#### [Docket No. 98-SW-74-AD]

#### Airworthiness Directives; Eurocopter Deutschland GmbH Model EC 135 Helicopters

**ACTION:** Notice of proposed rulemaking (NPRM).

**Figure 1**

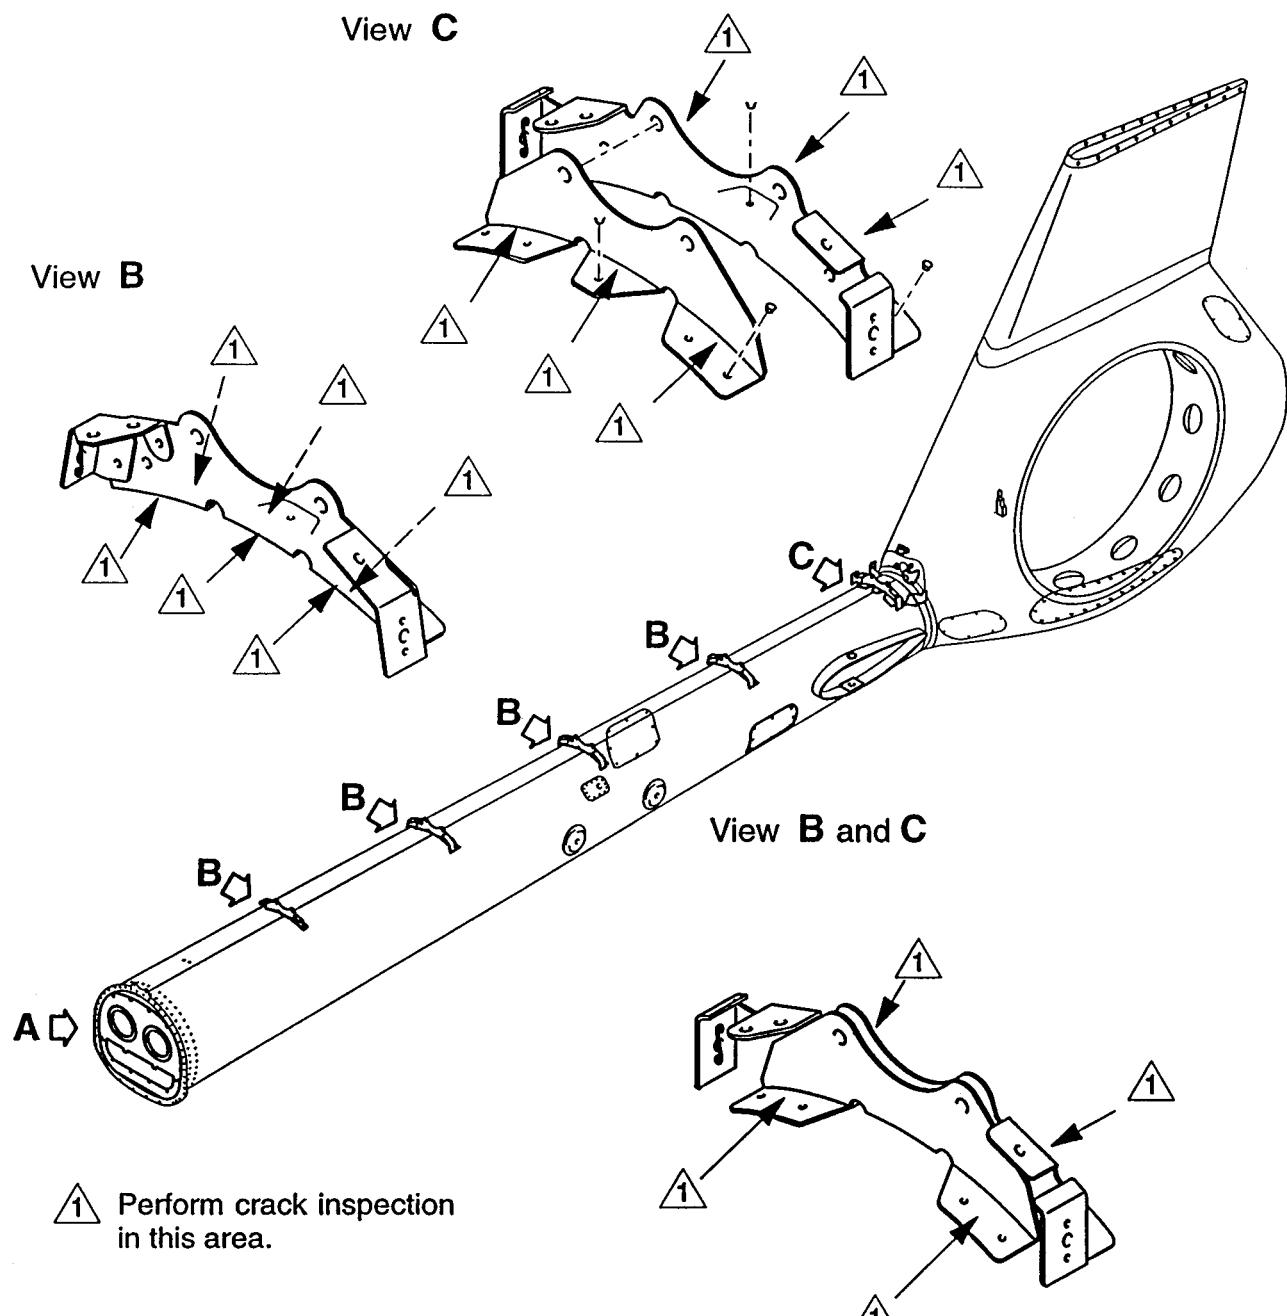
(1) Clean each tail rotor drive shaft bearing support. Using a 6-power or higher magnifying glass and a bright light, visually inspect the attach lugs of the bearing supports B and C (shown in Figure 1) for cracks, particularly in the area extending from the bend radius to the attaching screws and rivets connecting the bearing supports to the tail boom. Before further flight, replace each cracked bearing support with an airworthy bearing support.
